Facility: 10th & Cherry Parking Garage

Address: 1000 Cherry Street

Date of Survey: 02/02/10 & 02/03/10

Photo 2

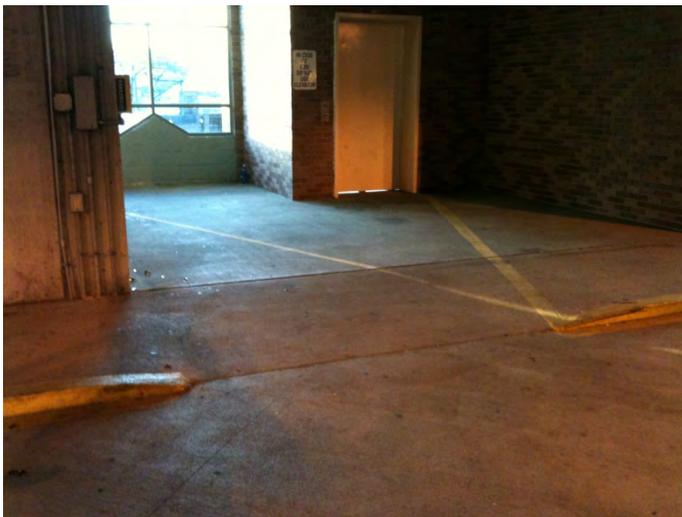
- Install contrasting color truncated dome detectable warning surface at transition from NW pedestrian access area (leading to/from elevator and stairs) to vehicular way @ four levels (see A on plan & photo 2 below). **Estimated Cost: \$4,888.00**

10TH & CHERRY PARKING STRUCTURE

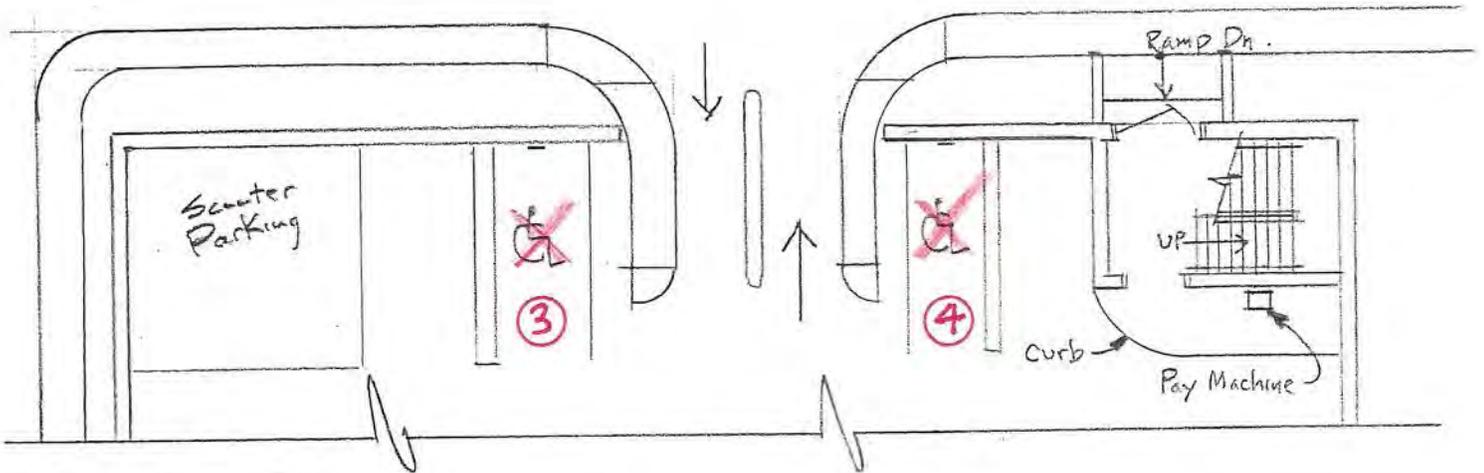
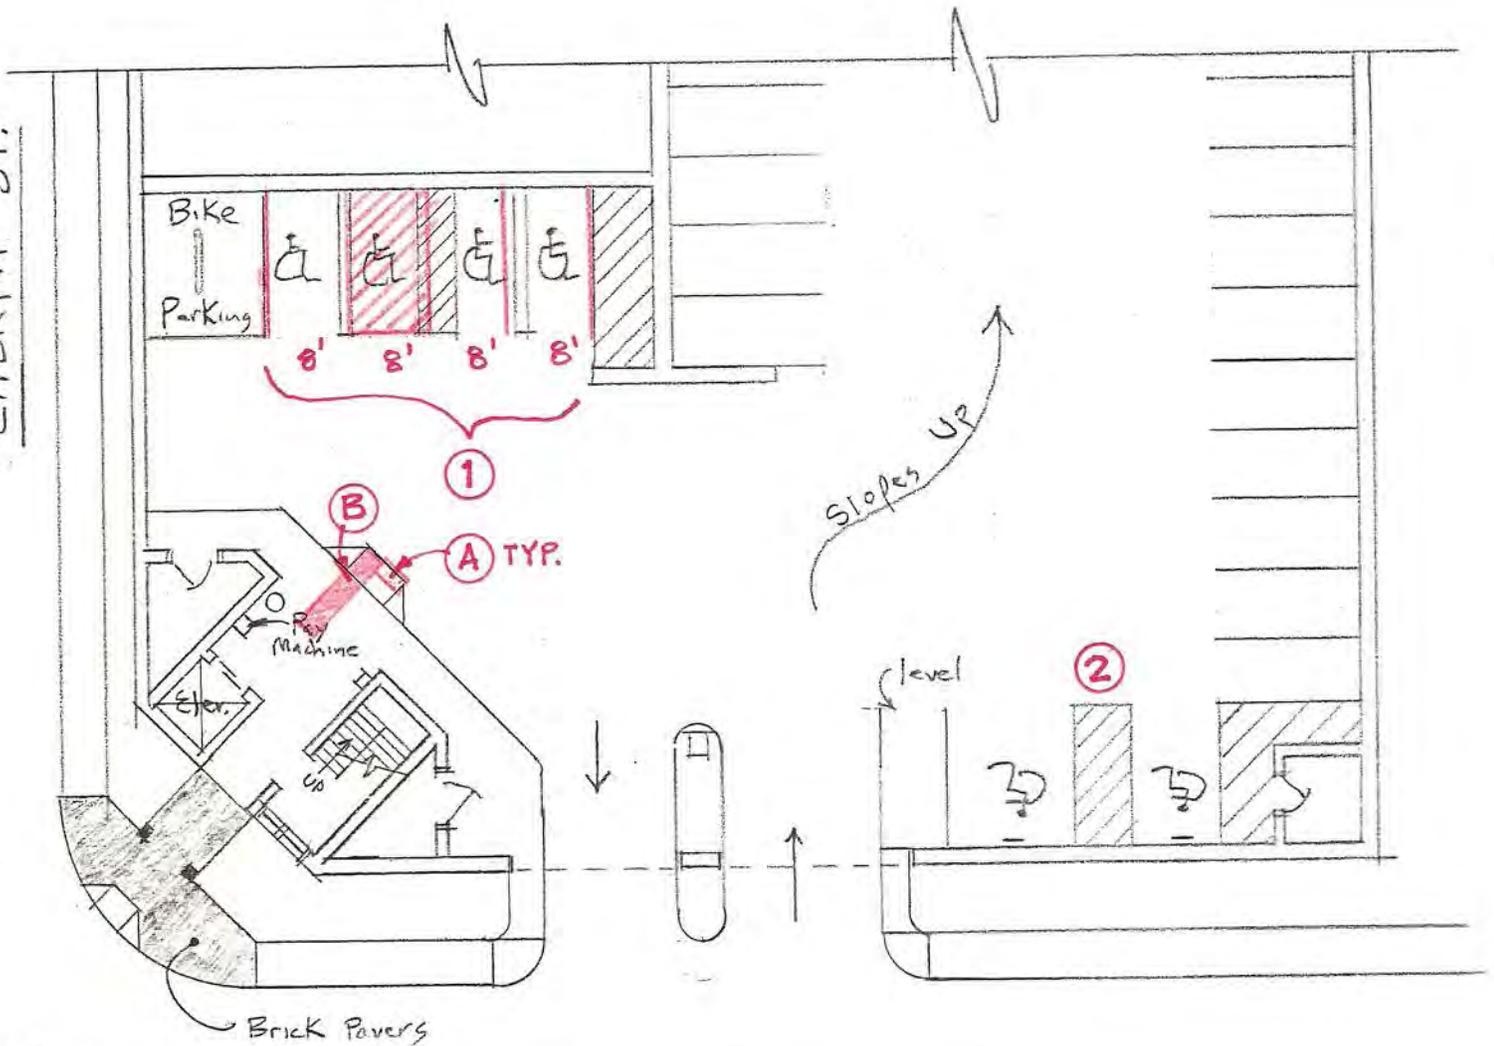
- Parking Area 1 (see plans): Reduce from four spaces to three spaces as current spaces are not wide enough and one space has no required access aisle. Restripe the spaces as shown in the plan (black represents existing spaces layout and red represents new space layout) and relocate signs as needed.
Estimated Cost: \$410.00

- Install new concrete ramp with rails (8.33% maximum slope) to provide ADA compliant access path from ADA parking spaces to NW pedestrian entrance area (see B on plan & photo 3 below). **Estimated Cost: \$6,200.00**
